Title: **STAGE 2 ROAD SAFETY AUDIT**  
**For;**  
**Main Street Ardee**

Client: **Louth County Council**

Report reference: **2067R02 Rev 2**

VERSION: **March 2025 Addendum.**

Drawing 533273-NOD-01-XX-DR-C-020107 Rev P06, Drainage design at the zebra crossing.

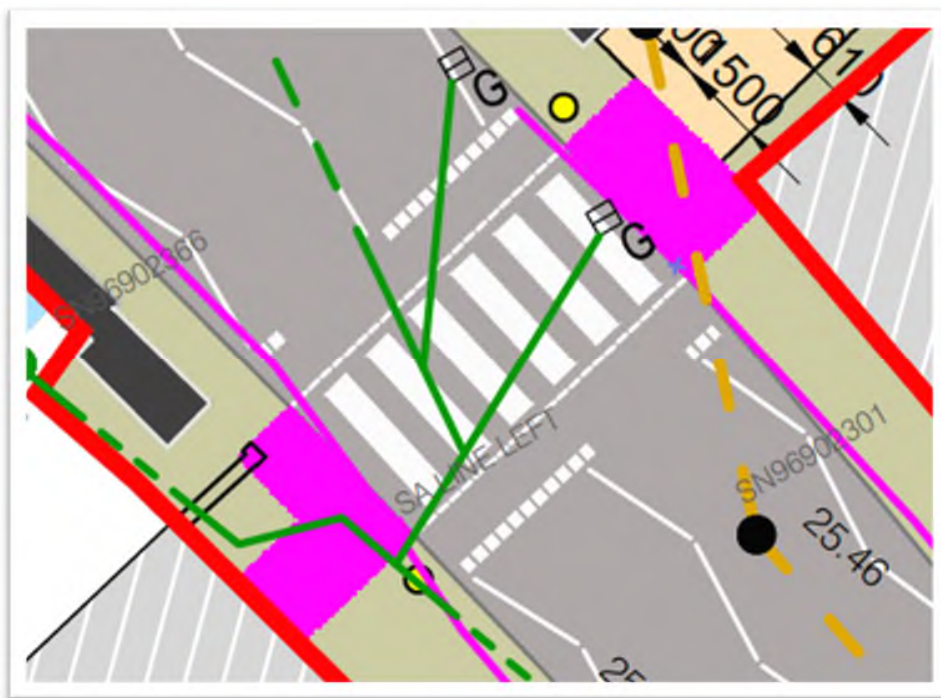
It is proposed to provide a road gully at the zebra crossing. This could lead to narrow wheels getting stuck or to those wearing narrow heels getting stuck and injured. There is also a risk that if the gully becomes blocked that surface water ponding will take place at the crossing location which could result in pedestrians crossing at another location where drivers do not expect or to slips and falls in icy conditions.

It is recommended that gullies be provided immediately upstream of the dropped kerb and not along the path of the crossing.
